# SUBDIVISION AUTHORITY MINUTES MEETING NO. 39

RE: REVISION of conditionally approved tentative plan of subdivision to subdivide a portion of Lot 10, Block 1, Plan 072 3500 to consolidate with Lot A Plan 1918 MC, located south of 105 Avenue NW and east of 184 Street NW; MORIN INDUSTRIAL

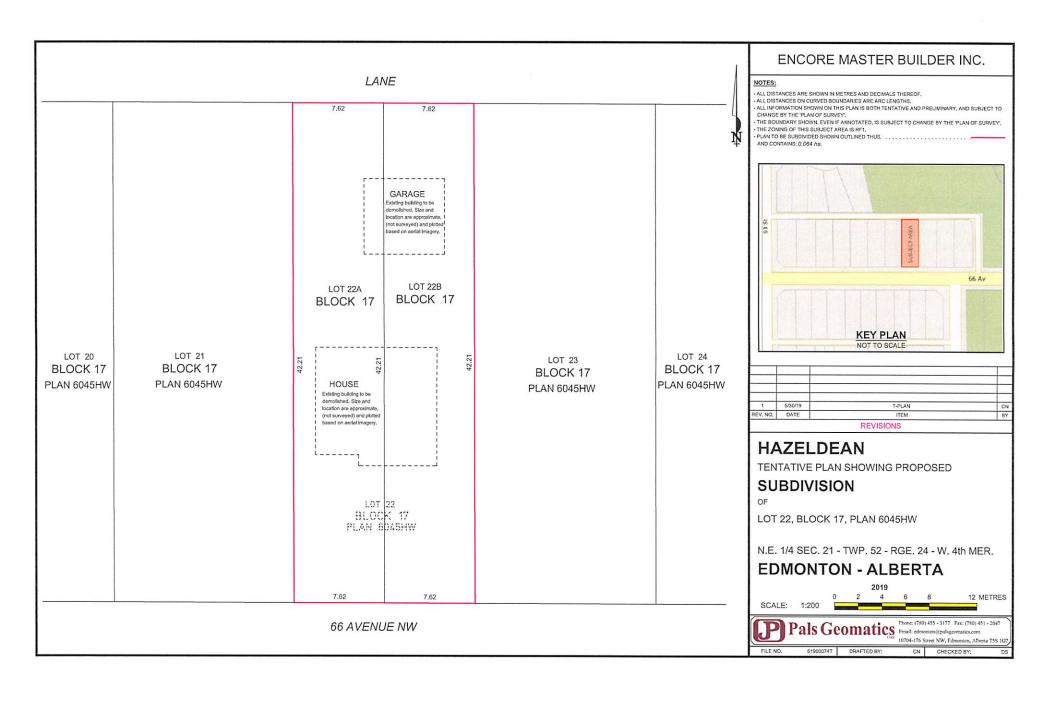
- The existing services (water and sanitary) enter the proposed subdivision approximately 5.7 m west of the east property line of Lot 22 off of the lane. The existing storm service enters the proposed subdivision approximately 8.4 m west of the east property line of Lot 22 off 66 Avenue NW. As per the EPCOR Drainage Services Bylaw and the EPCOR Water Services and Wastewater Treatment Bylaw, these services cannot cross the proposed property line.

- There is a deficiency in on-street hydrant spacing adjacent to the property. The applicant/owner is advised to review on-site fire protection requirements to ensure adequate coverage (contact EPCOR Water at 780-412-3955).

- There is an existing power pole that will interfere with access to the proposed Lot 22A. Subdivision Planning highly recommends that the applicant/owner initiate the relocation of the power pole/guy wire with EPCOR Distribution & Transmission as soon as possible as this pole will inhibit alley access to the site and will result in a delay with the issuance of the Development Permit. Contact Andy Balding (780-412-3520) of EPCOR Distribution & Transmission for more information.

## PLAN OF PROPOSED SUBDIVISION

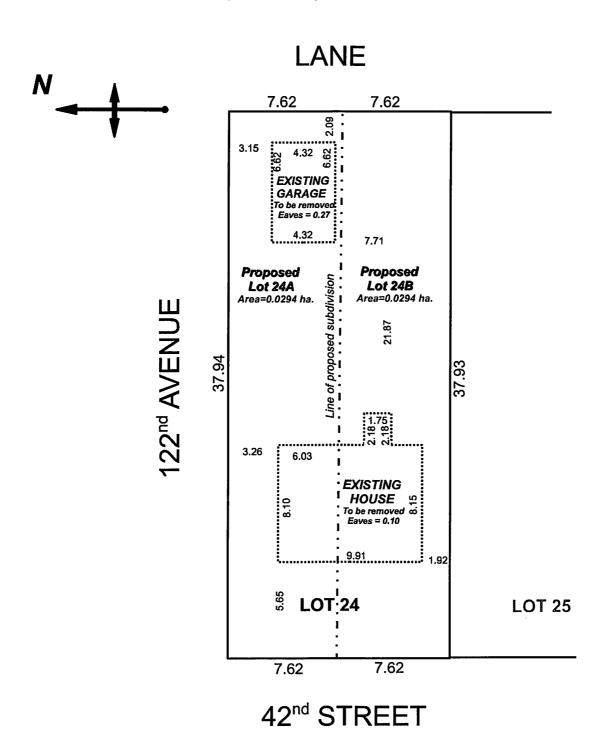
- The existing services (water and sanitary) enter the proposed subdivision approximately 3.6 m south of the north property line of Lot 24 off 42 Street NW. As per the EPCOR Drainage Services Bylaw and the EPCOR Water Services and Wastewater Treatment Bylaw, these services cannot cross the proposed property line.

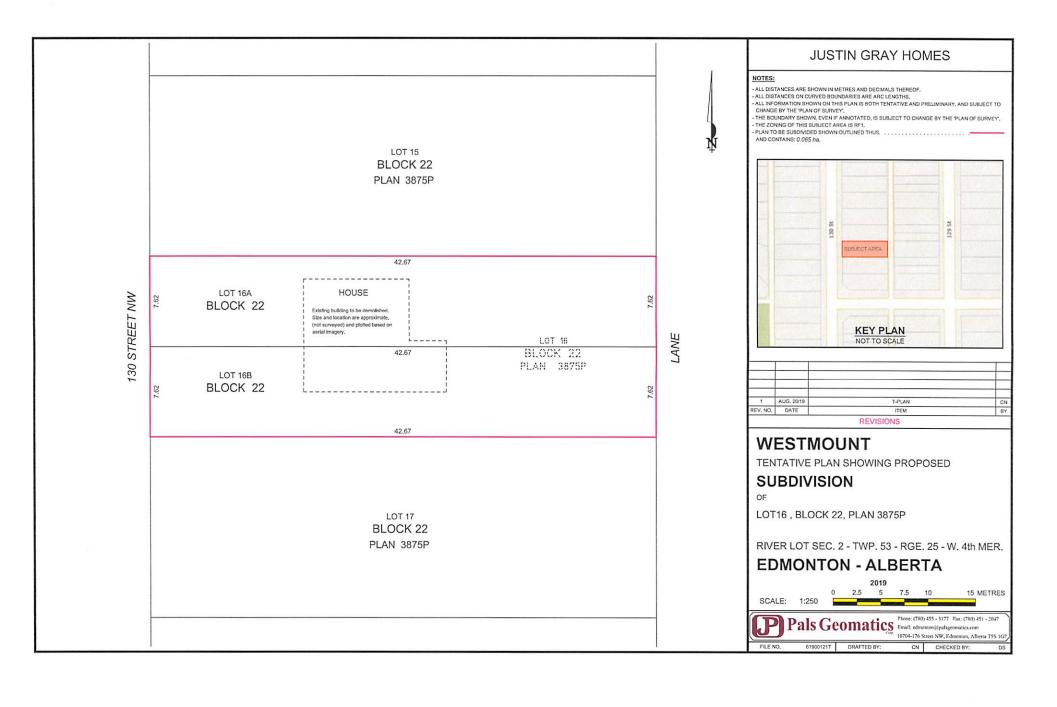
- The existing services (water and sanitary) enter the proposed subdivision approximately 11.3 m north of the south property line of Lot 16 off of the lane. As per the EPCOR Drainage Services Bylaw and the EPCOR Water Services and Wastewater Treatment Bylaw, these services cannot cross the proposed property line.

- There is a deficiency in on-street hydrant spacing adjacent to the property. The applicant/owner is advised to review on-site fire protection requirements to ensure adequate coverage (contact EPCOR Water at 780-412-3955).

## TENTATIVE PLAN

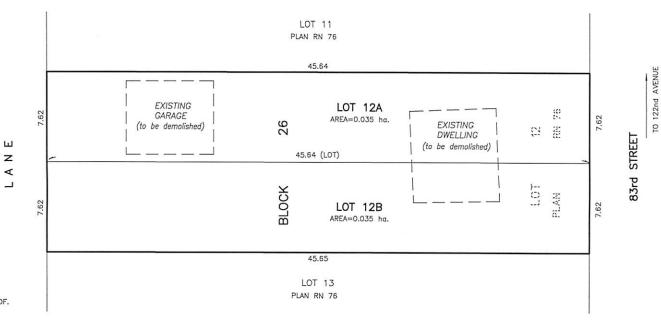
- The existing services (water and sanitary) enter the proposed subdivision approximately 4.0 m north of the south property line of Lot 12 off of the lane. As per the EPCOR Drainage Services Bylaw and the EPCOR Water Services and Wastewater Treatment Bylaw, these services cannot cross the proposed property line.

- There is a deficiency in on-street hydrant spacing adjacent to the property. The applicant/owner is advised to review on-site fire protection requirements to ensure adequate coverage (contact EPCOR Water at 780-412-3955).
